**ADDENDUM
NO. 1**

**Portage Township School - Bid Package #2
PHS Learning Lab, Elementary Schools Media Centers, and Office Renovation
Portage IN, 46368**

ADDENDUM NO. 1

RE: LEARNING LAB, MEDIA CENTERS & OFFICE PROJECT
Portage Township Schools
Portage, Indiana

DATE: 10-18-21
 PROJECT NO.: 212562
 CAD NAME: TITLE E6.2
 SHEET NO.:
 TITLE E6.2-10-18-21b

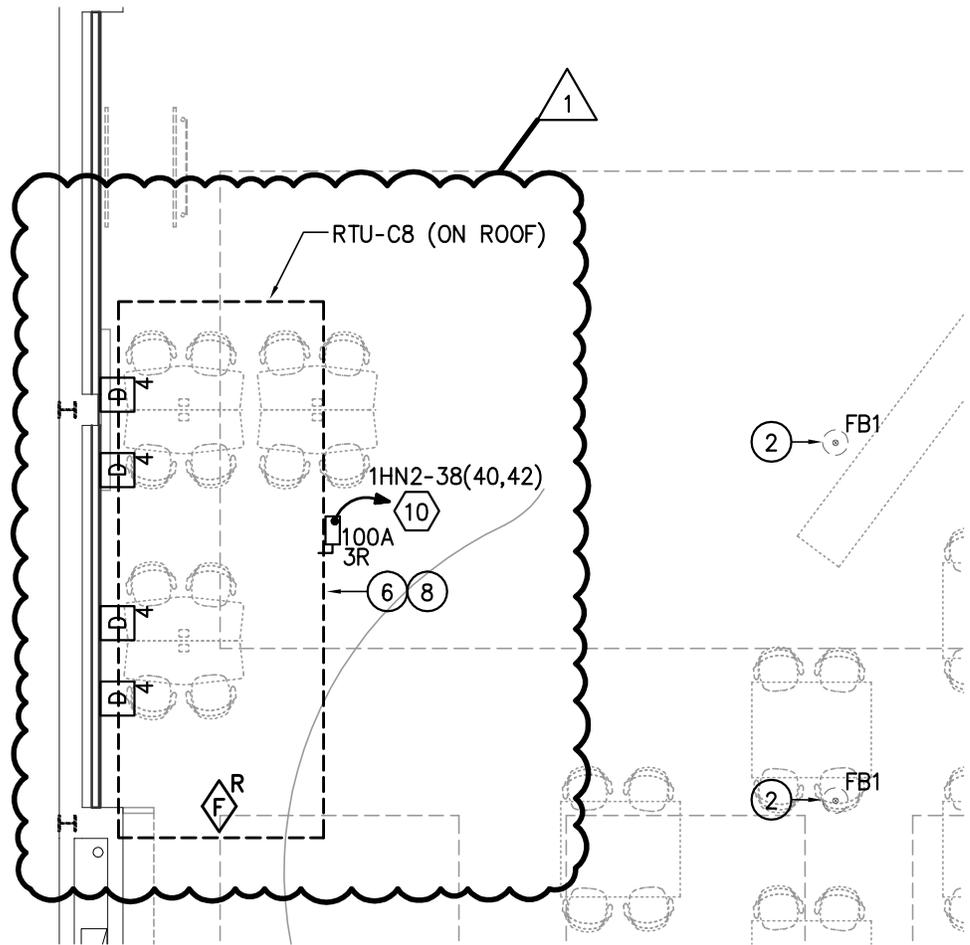
6. **DRAWINGS; Sheet No. TITLE E6.2:**
 - a. **EXISTING ELECTRICAL RISER DIAGRAM NOTES:** Revise note 3 as shown on Addendum Drawing No. TITLE E6.2a, dated 10/18/21.

- b. **PROPOSED ELECTRICAL LAB RISER DIAGRAM AND NOTES:** Revise the Riser Diagram and Notes as shown on Addendum Drawing No. TITLE E6.2b, dated 10/18/21.

- ① EXISTING PANEL TO BE REMOVED.
- ② REMOVE EXISTING CIRCUIT WIRES BACK TO THE SOURCE. EXISTING STUBBED UP UNDERGROUND CONDUIT TO BE REMOVED. REFER TO PROPOSED ELECTRICAL LAB RISER DIAGRAM.
- ③ EXISTING FUSE TO REMAIN AND LEAVE AS SPARE.

- ① NEW EXPOSED INDOORS CONDUIT AND WIRES FOR NEW PANEL 1HV1. REFER TO POWER AND CONDUITS SCHEDULE. PROVIDE A 100A, 480V, 3PH BREAKER AT EXISTING PANEL "1HN2" COMPATIBLE WITH EXISTING PANEL MANUFACTURER.
- ② NEW WALL MOUNTED TRANSFORMER. CONTRACTOR TO PROVIDE WALL MOUNTED ACCESSORIES AS NEEDED. REFER TO TRANSFORMER SCHEDULE FOR MORE DETAILS.

DATE: 10-18-21
 PROJECT NO.: 212562
 CAD NAME: LAB E3.0
 SHEET NO.:
 LAB E3.0-10-18-21

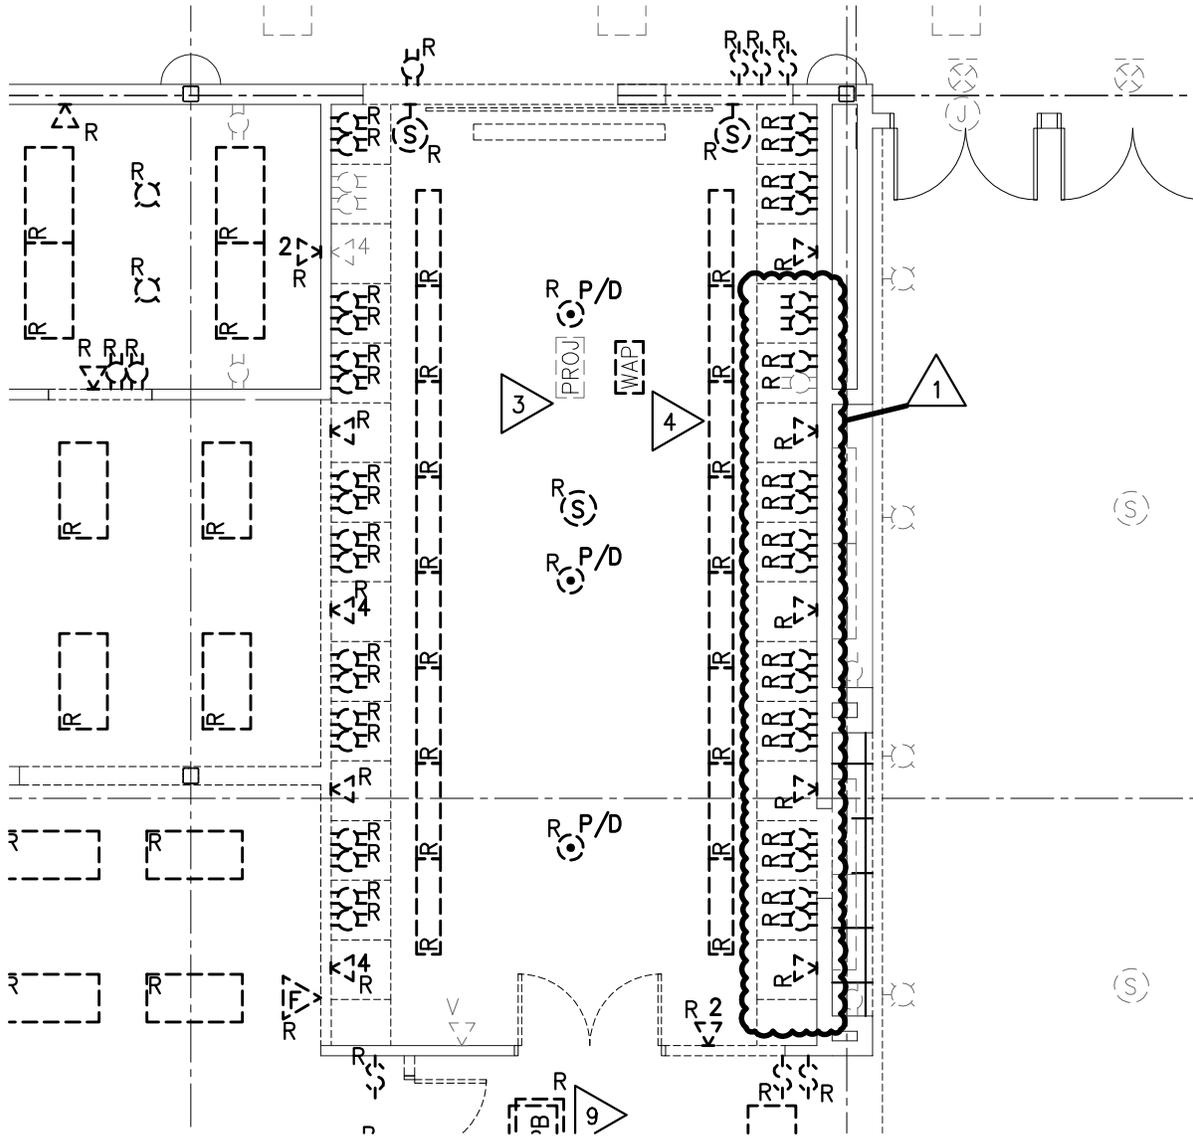
7. **DRAWINGS; Sheet No. TITLE E6.3:**
 - a. **PANEL 1HV1:** Revise the main breaker ampacity to 100A.
8. **DRAWINGS; Sheet No. LAB E3.0:**
 - a. **ELECTRICAL SYSTEM PLAN AND NOTES:** Revise the Electrical System Plan and Electrical Plan Notes as shown on Addendum Drawing No. LAB E3.0, dated 10/18/21.

- ① FLOOR BOX INSTALLED IN FACE OF RAMP WALL.
- ② EXISTING LEGRAND FSR (FL-500P) FLOOR BOX FOR POWER, DATA AND A/V TO REMAIN.
- ③ EXISTING STUB CONDUITS FROM FLOOR BOXES TO REMAIN.
- ④ REFER TO NOTE 14 ON SHEET E1.0.
- ⑤ REFER TO NOTE 15 ON SHEET E1.0.
- ⑥ MECHANICAL EQUIPMENT PROVIDED AND INSTALLED BY ANOTHER CONTRACTOR. COORDINATE EXACT LOCATION WITH PROVIDER AND TERMINATE AS REQUIRED. WHERE NO STARTERS, DISCONNECTS, OR SWITCHES ARE INDICATED, THEY WILL BE FACTORY MOUNTED AND LOAD-SIDE WIRED.
- ⑦ DOOR HOLDERS PROVIDED AND INSTALLED BY OTHERS. ELECTRICAL CONTRACTOR SHALL TERMINATE TO FIRE ALARM PANEL SUCH THAT UPON FIRE ALARM ACTIVATION, HOLDERS RELEASE. RE-PROGRAM FACP AS REQUIRED FOR A COMPLETE AND FUNCTIONAL SYSTEM.
- ⑧ PANELBOARD 1HN2 LOCATED IN BOILER ROOM N-105. FOR BIDDING PURPOSES USE 200FT LONG POWER CIRCUIT.

DATE: 10-18-21
 PROJECT NO.: 212562
 CAD NAME: OFFICE E0.1
 SHEET NO.:
 OFFICE E0.1-10-18-21

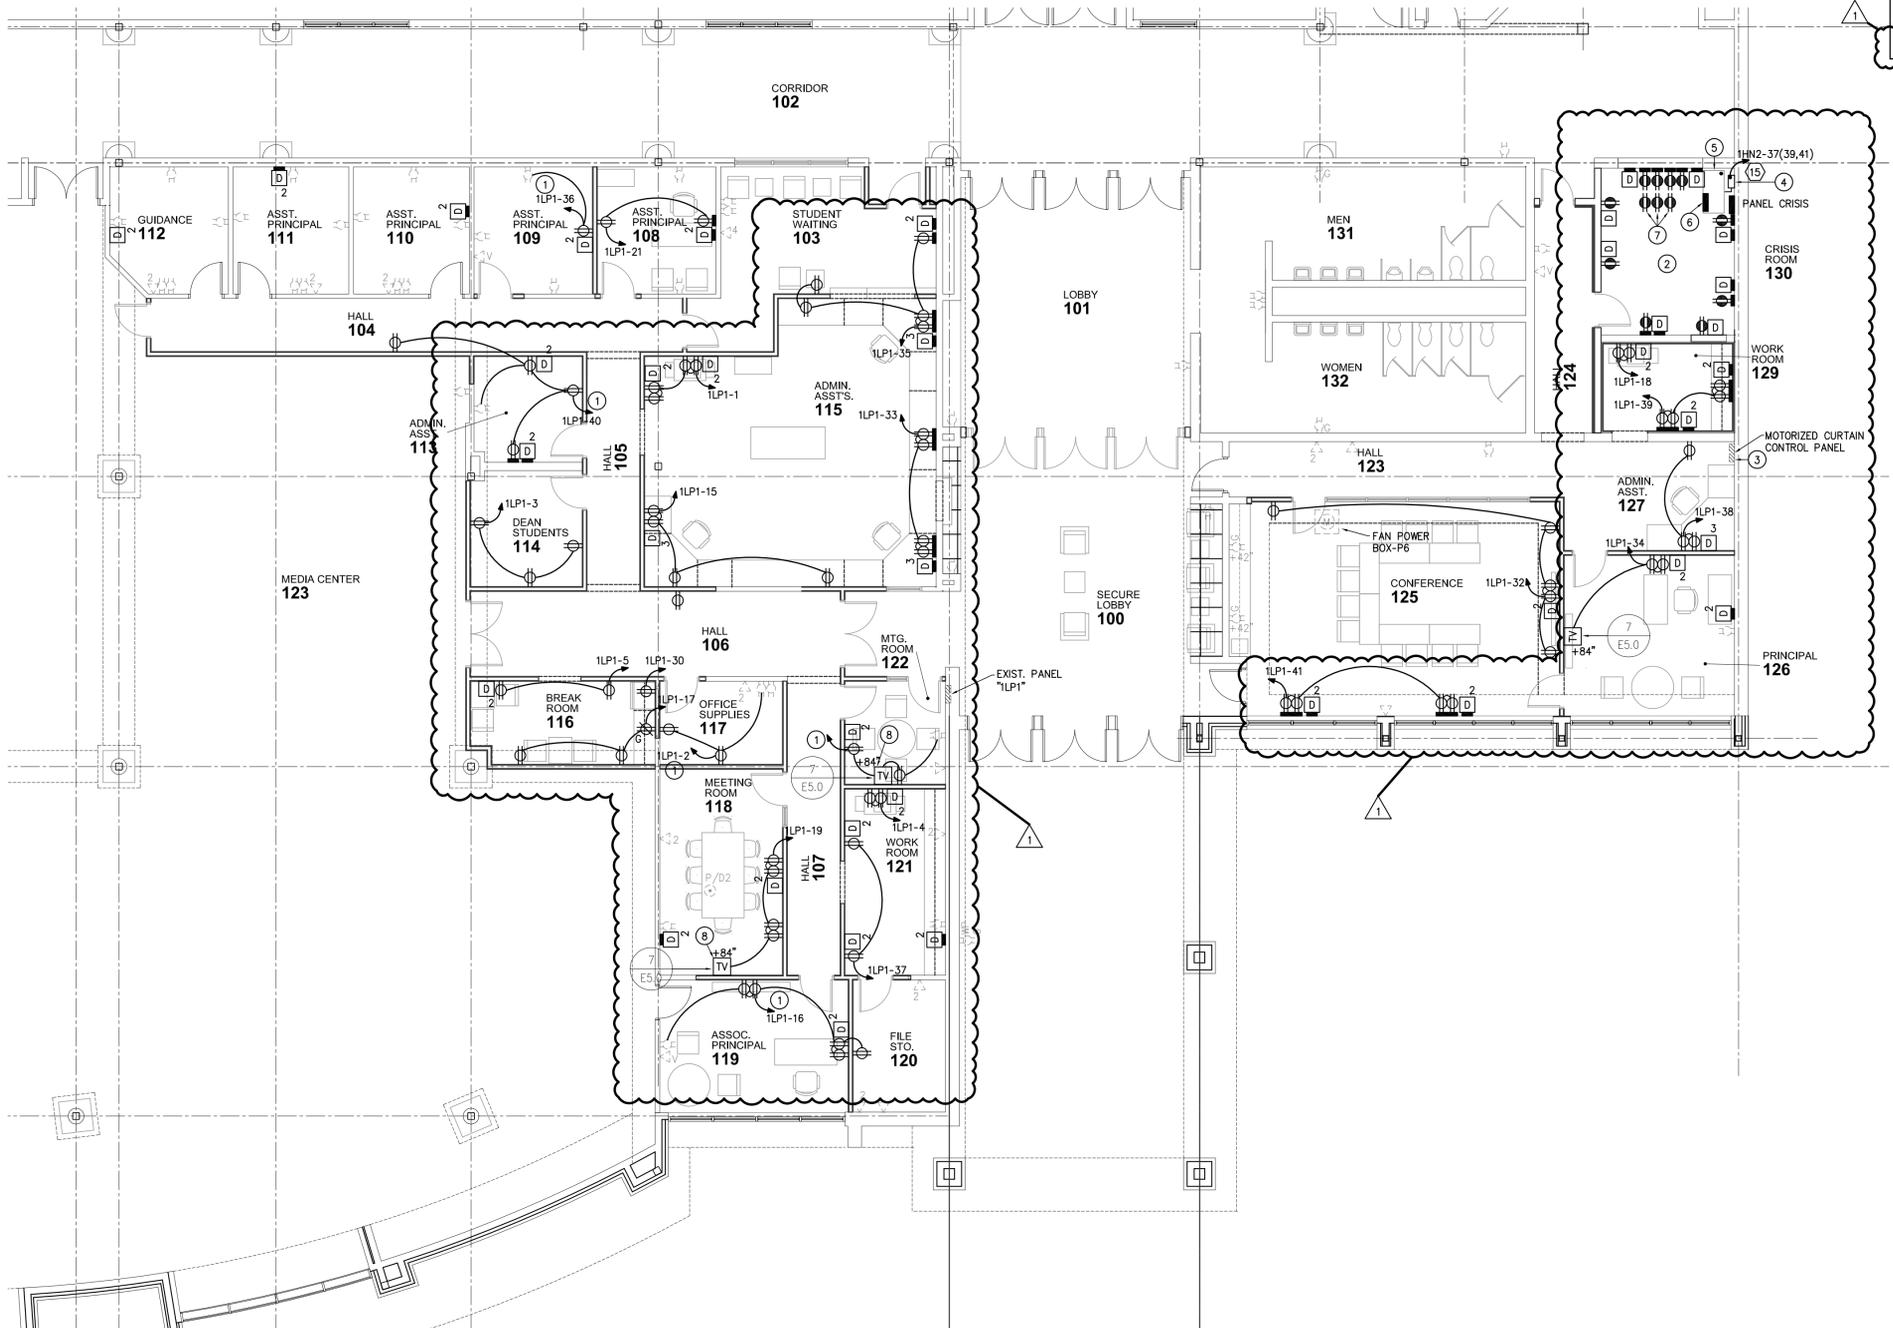
9. **DRAWINGS; Sheet No. OFFICE E0.1; ELECTRICAL DEMOLITION PLAN:** Revise the Electrical Demolition Plan as shown on Addendum Drawing No. OFFICE E0.1, dated 10/18/21.

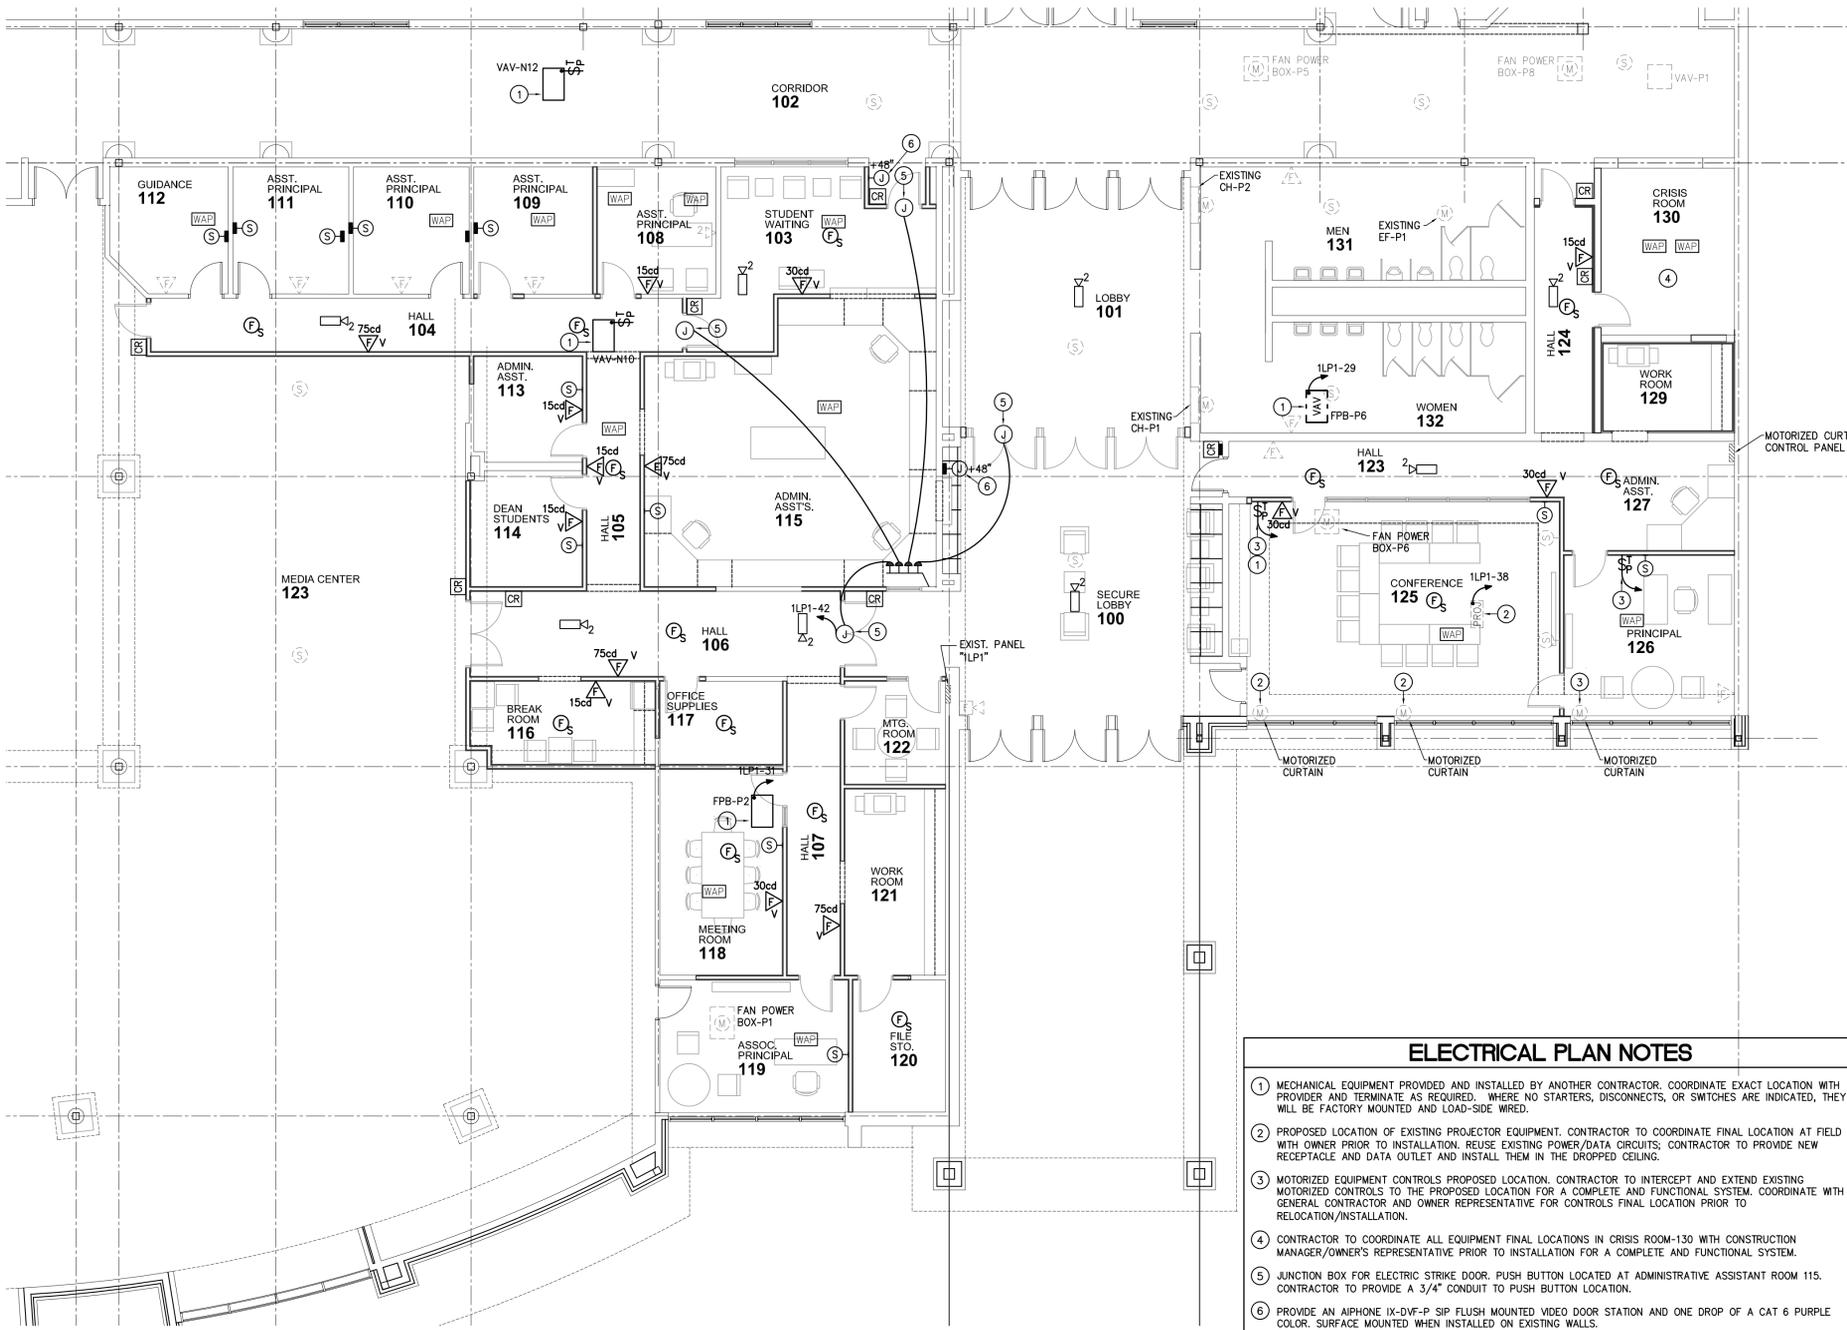
10. **DRAWINGS; Sheet No. OFFICE E1.0:** replace this sheet in its entirety with the attached Sheet OFFICE E1.0, dated ADD-1 (10/18/2021). Note that the power distribution has been revised in the Administration Offices and Crisis Room.

11. **DRAWINGS;** Sheet No. OFFICE E3.0: replace this sheet in its entirety with the attached Sheet OFFICE E3.0, dated ADD-1 (10/18/2021). Note the addition of the DATA CABLE SPECIFICATIONS.

DATA CABLE SPECIFICATIONS

A. THE HORIZONTAL CABLE SYSTEM SHALL BE CATEGORY 6 UNSHIELDED TWISTED PAIR (UTP) PLENUM RATED CABLE. THE CABLE RUN SHALL BE FROM EACH USER LOCATION TO THE (IDF/MDF-E IN ROOM L-104). THE PROPOSED DATA CABLE SHALL COMPLY WITH THE EIA/TIA-568-C.2 STANDARDS WITH GUARANTEED ELECTRICAL PERFORMANCE TO 400 MHZ.
